Our ref: 41/16384/359673  
Your ref:

**Bell Bay Pulp Mill  
Response to DTAE Questions of 18th June**

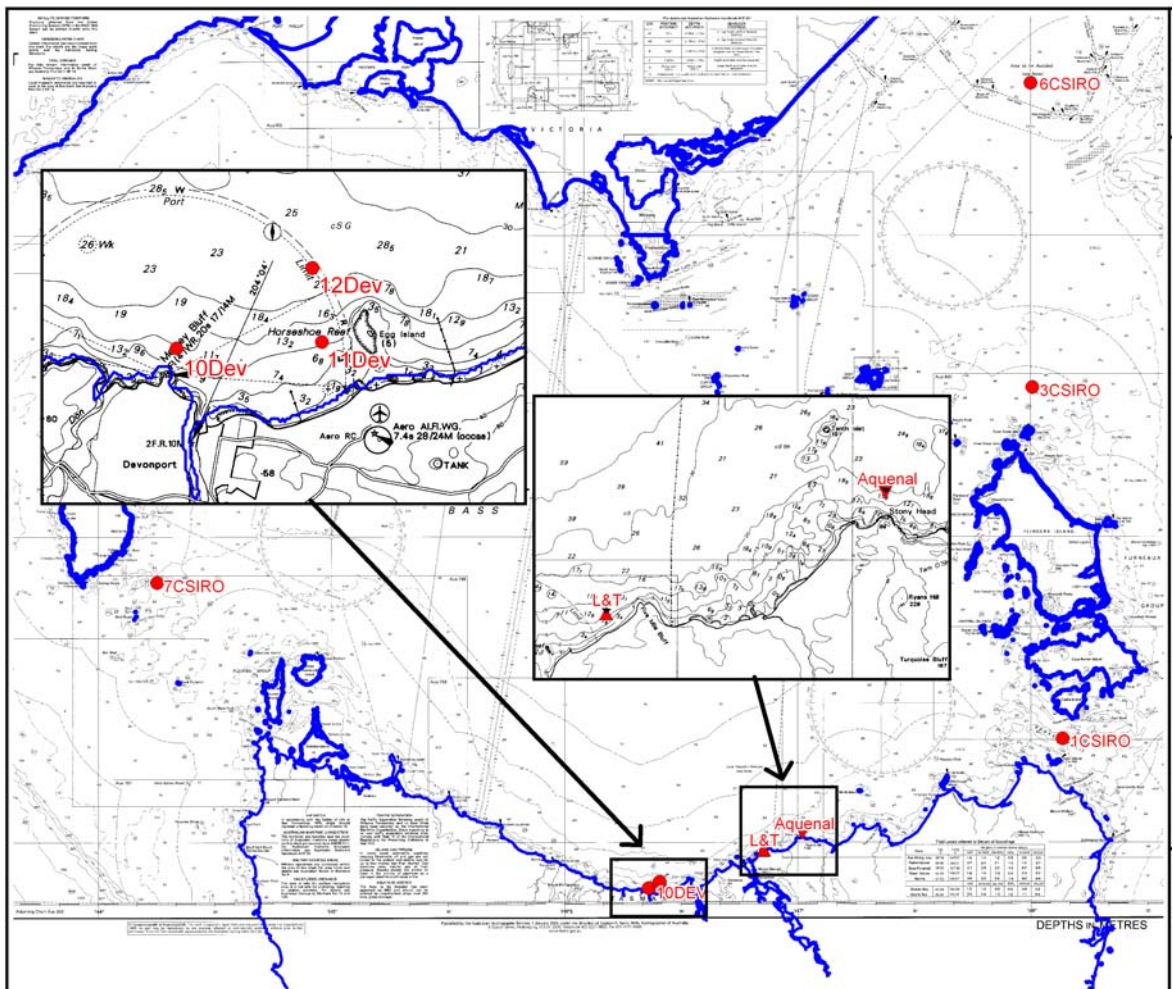
1. The data set that has been used in the model calibration of the model is not readily described in the reports. It is unclear whether historical non concurrent data have been used or whether data from the field campaign in December 2005 has been used. Clarification is requested.

The July 2006 report states that whilst calibration to tide levels for April 2005 was achieved, no concurrent data pertaining to currents was available at the time the model was first created. For this reason, a model verification process was adopted using measured currents from a number of locations throughout Bass Strait. Figure 4.3 from the July 2006 report is reproduced below. This illustrates locations where current data was available.

Table 9 from the July 2006 report (reproduced below) highlights the dataset originally used for model verification.

Given that all datasets came from different times, a statistical analysis was employed in order to verify the model performance. That is, a statistical representation of current magnitude and direction for each location was compared to model results for the same location. Good matches were achieved.
